T10/05-xxx revision 0

Date: March 04, 2005

From: George Penokie (IBM/Tivoli); Mark Evans (Maxtor)

Subject: SAS 1.1 - Link and Port layer state machine fixes

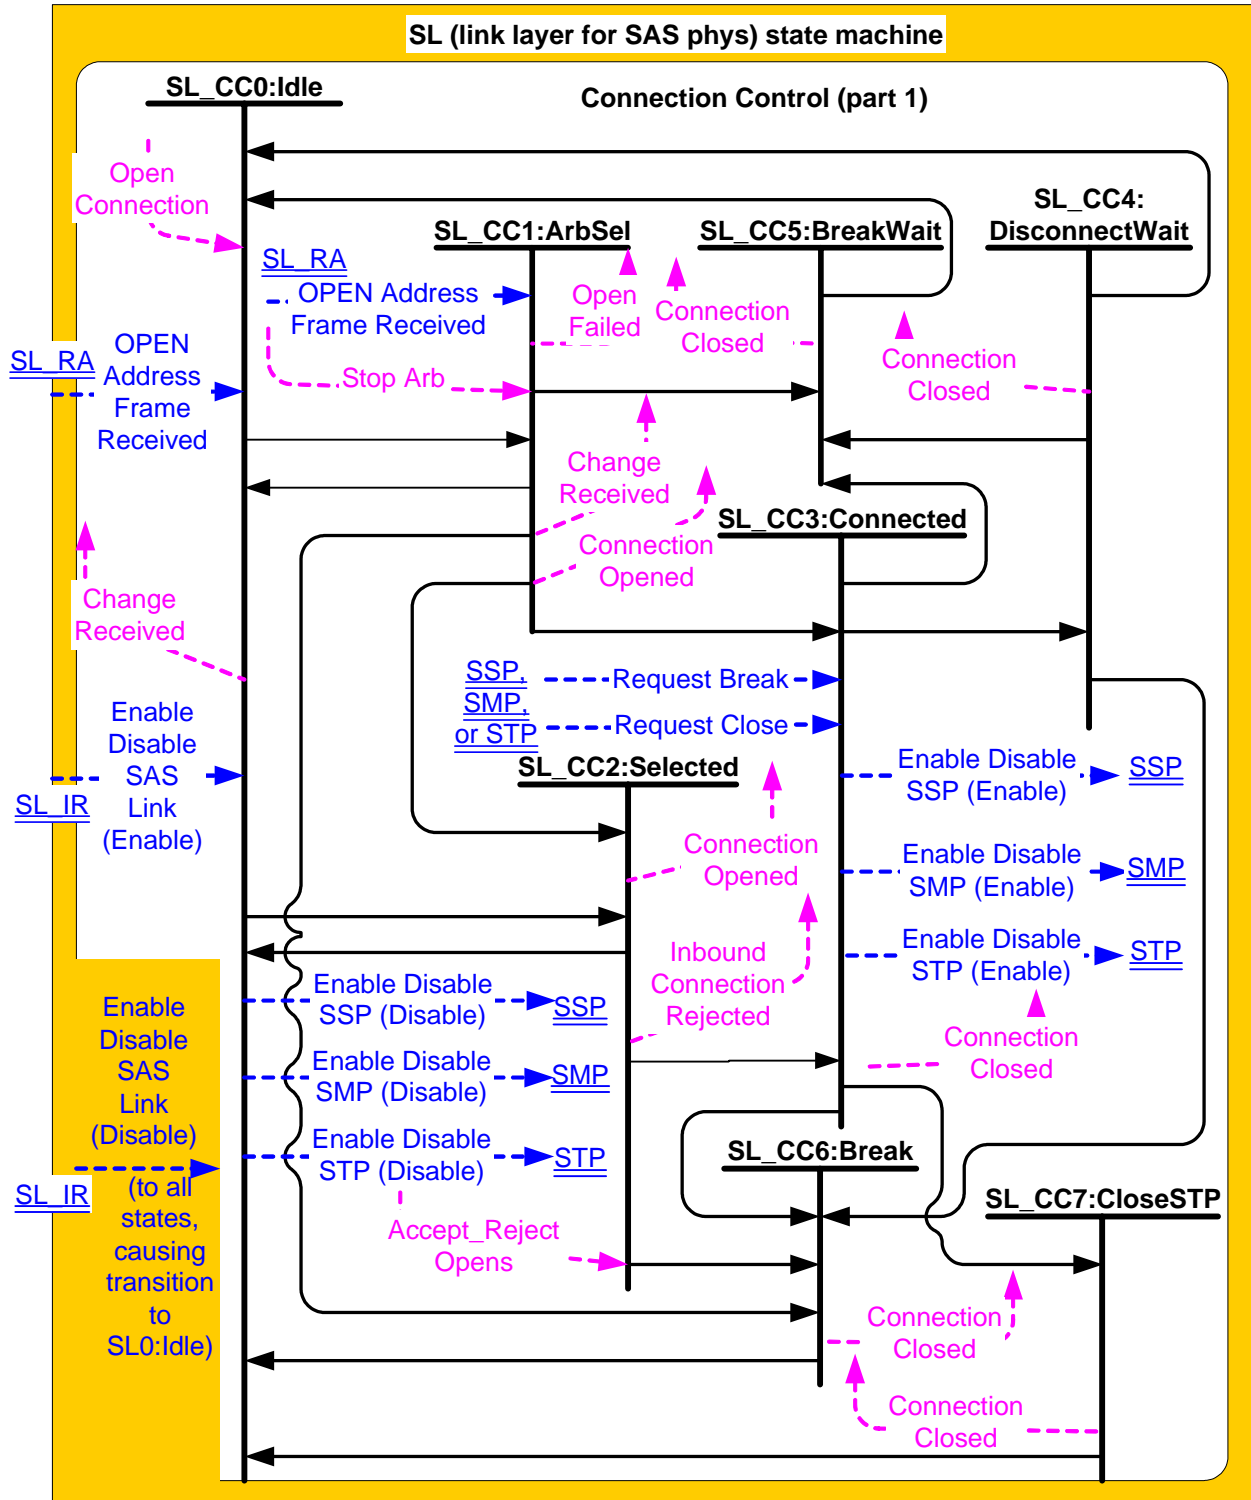
- In the SL_CC5:BreakWait state there is a Connection Closed confirmation shown in the state machine figure but there is no description in the text as to when to send it or which Connection Closed it.
- In the SL_CC2:Selected state there is an Inbound Connection Reject confirmation that is not shown in the port layer state machines.
- There is a period of time when the PL_PM state could send an Open Connection request that would be ignored because the SL state machine is not in SL_CC0:Idle. The result of this would be that PL_PM would hang in the PL_PM2:Req_Wait state. This is most likely to occur as the result of sending or receiving a BREAK.

The solution to these problems is to add a new argument to the Connection Closed confirmation in the SL_CC6:Break and SL_CC5:BreakWait states that would indicate that a Transition to Idle occurred as a result of a BREAK primitive. This would cause the PL_PM states to transition to PL_PM1:Idle thereby removing the hang.

Change figure 126 to add in a Connection Closed confirmation exiting from the SL_CC6:Break state as shown below.

This transition shall occur after [sending a Connection Closed \(Break to Idle\) confirmation to the port layer if:](#)

- a) ~~receiving~~ a BREAK Received message [is received](#);
- b) ~~receiving~~ an OPEN_REJECT Received message [is received](#); or
- c) the Break Timeout timer expires.

This transition shall occur after sending a Transmit BREAK message to the SL transmitter [and sending a Connection Closed \(Break to Idle\) confirmation to the port layer.](#)

Figure 1 — PL_PM (port layer phy manager) state machine (part 1)

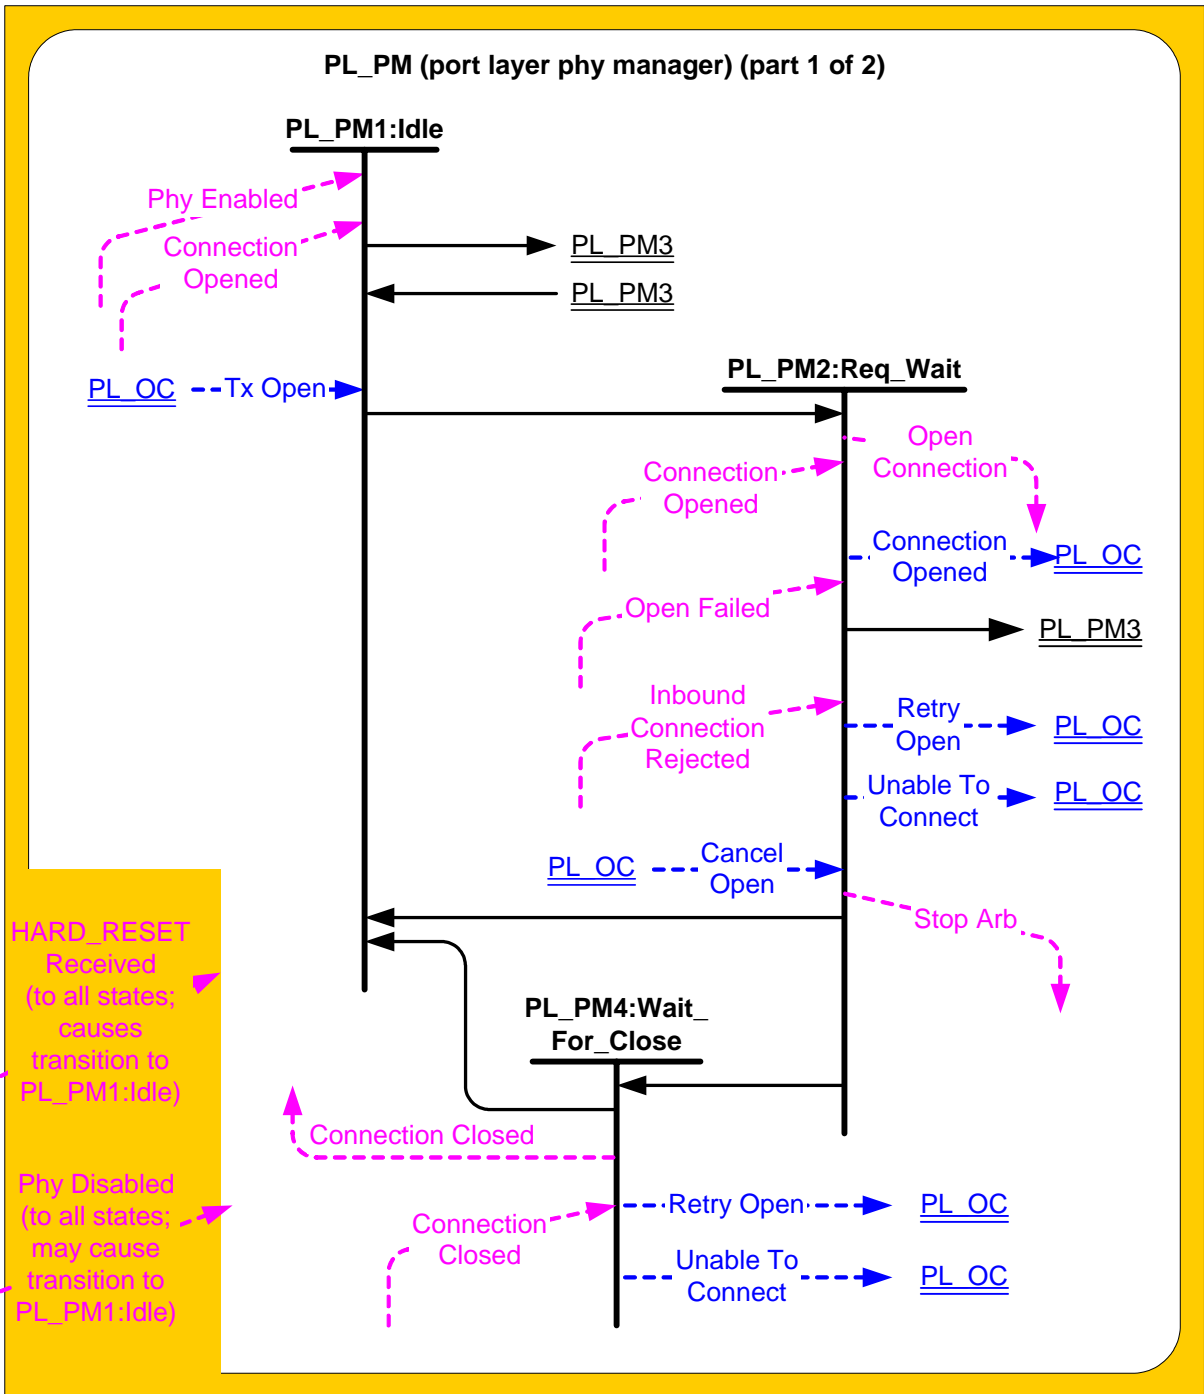
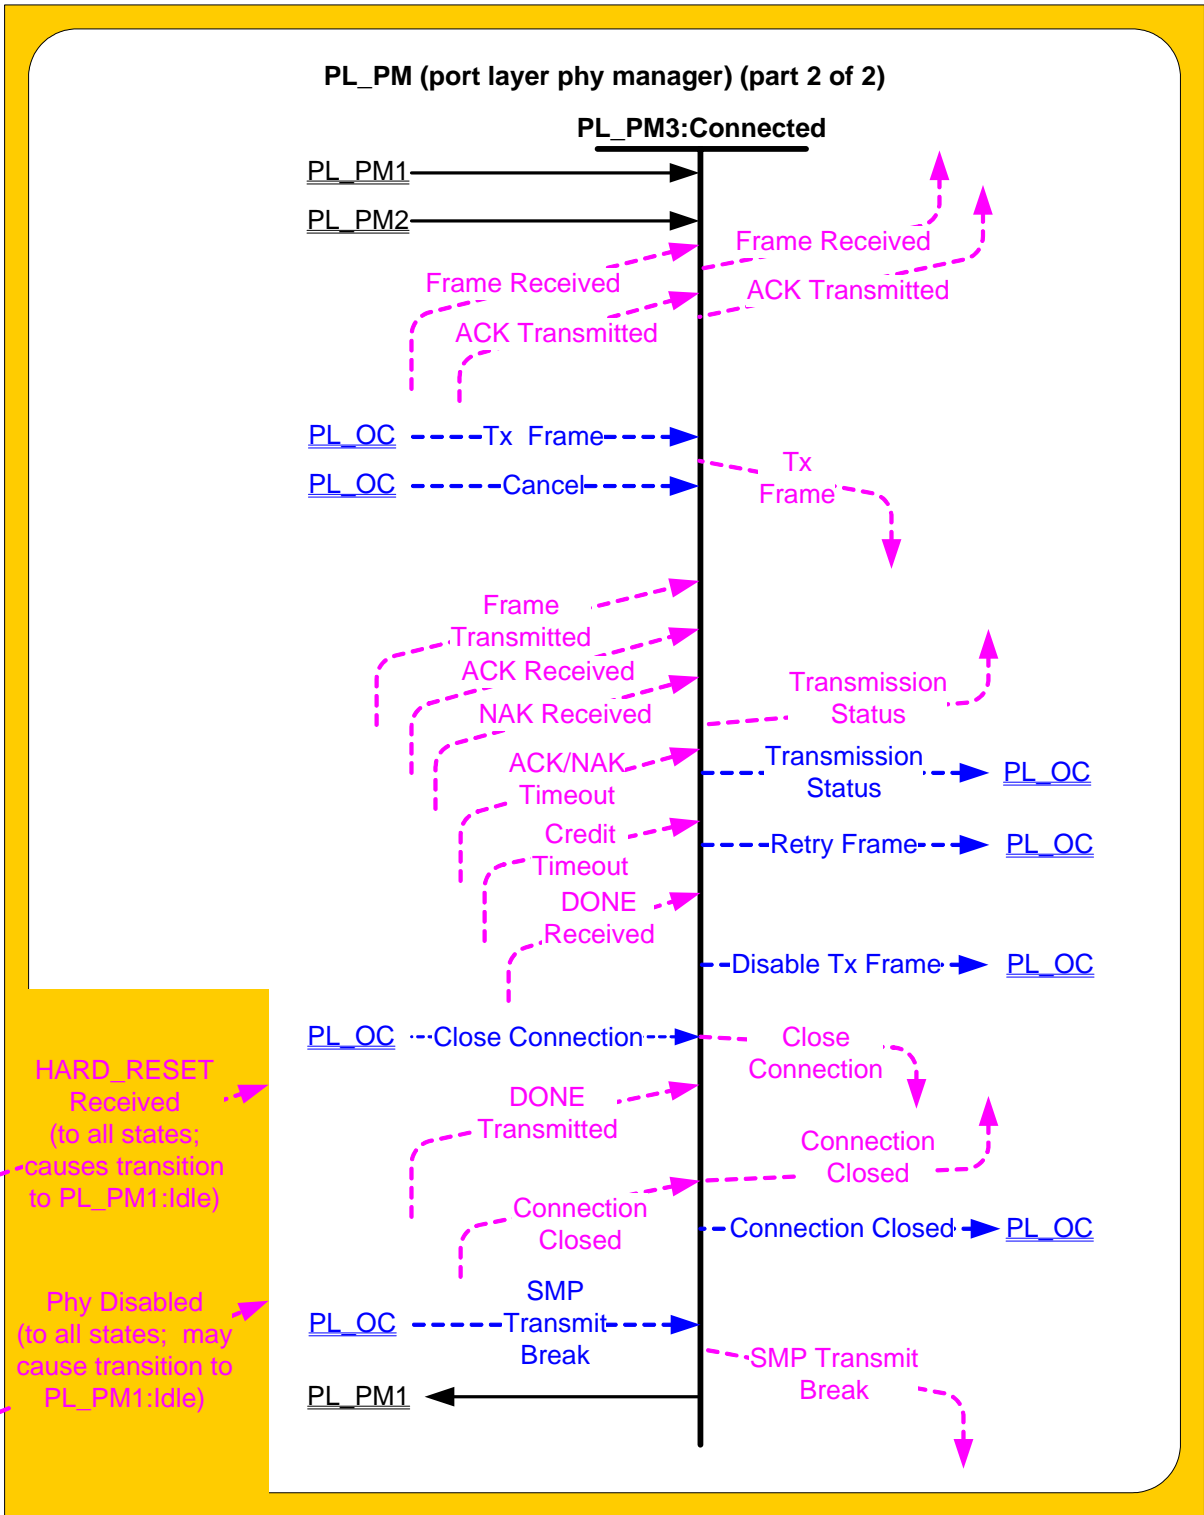
Add to figure 147 an Inbound Connection Rejection confirmation going to the PL_PM2:Req_Wait state. As shown in the figure below.

If this state receives an Inbound Connection Rejected confirmation after sending an Open Connection request, then this state shall discard the Open Connection request and send a Retry Open (Collided) message to the PL_OC state machine.

- a) an Open Failed (Open Timeout Occurred)
- b) [an Open Failed \(Break Received\); or](#)
- c) an Open Failed (Port Layer Request).

[If this state receives a Connection Closed \(Break to Idle\) confirmation, then this state shall send a Connection Closed message to the PL_OC state machine.](#)
